Access Compliance Report

Public Rights-of-Way

Intersection ID: N/A	Main Street: MILLENNIUM_AV	Cross Street: ANSLEY_GARDEN_DR	Location: SE
ADA ID: E0B1EBD59D2F	Ramp Type: Directional1	Initial Pass/Fail: Fail	Overall Compliance: No
Severity Score: 1.25			
Codes/Mitigation Info/Possible Solution		Field Measurements/Component Compliance

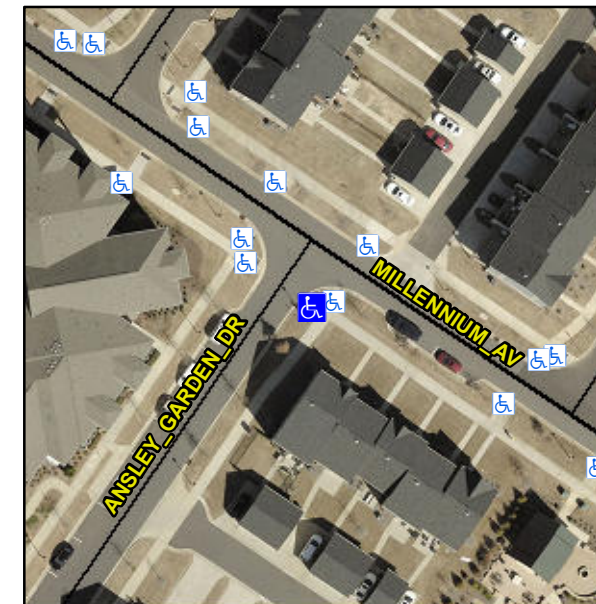
Remove & Replace Entire Ramp.

R304.5.3

Compliance	Description	Data	Compliance	Description	Data
N/A	Ramp Length (in)	90.0	N/A	Grade Break?	N/A
Yes	Ramp Width (in)	70.0	N/A	Grade Break Slope (%)	0.0
Yes	Ramp Slope (%)	5.9	N/A	Grade Break XSlope (%)	0.0
No	Ramp XSlope (%)	2.3			
N/A	Flare Type LT	N/A	N/A	Flare Type RT	N/A
N/A	Flare Slope LT (%)	N/A	N/A	Flare Slope RT (%)	0.0
N/A	Flare Traversable LT?	N/A	N/A	Flare Traversable RT?	N/A
N/A	Landing Length (in)	0.0	N/A	DWS Provided?	N/A
N/A	Landing Width (in)	0.0	N/A	DWS Contrast?	N/A
N/A	Landing Slope (%)	0.0	N/A	DWS Length (in)	N/A
N/A	Landing X Slope (%)	0.0	N/A	DWS Full Width?	N/A
N/A	Landing Curb? (Y/N)	N/A	N/A	DWS Offset LT (in)	N/A
N/A	Shared Landing?	N/A	N/A	DWS Offset RT (in)	N/A
N/A	Gutter Ponding?	0.0	N/A	Gutter Slope (%)	N/A
N/A	Gutter Lip Ht (in)	0.0	N/A	Gutter X Slope (%)	N/A
N/A	Painted X Walk1?	No		Road Slope (%)	3.0
	X Walk 1 Direction	To NW		Road X Slope (%)	2.0
	X Walk 1 Width (in)	N/A		Clear Space?	N/A
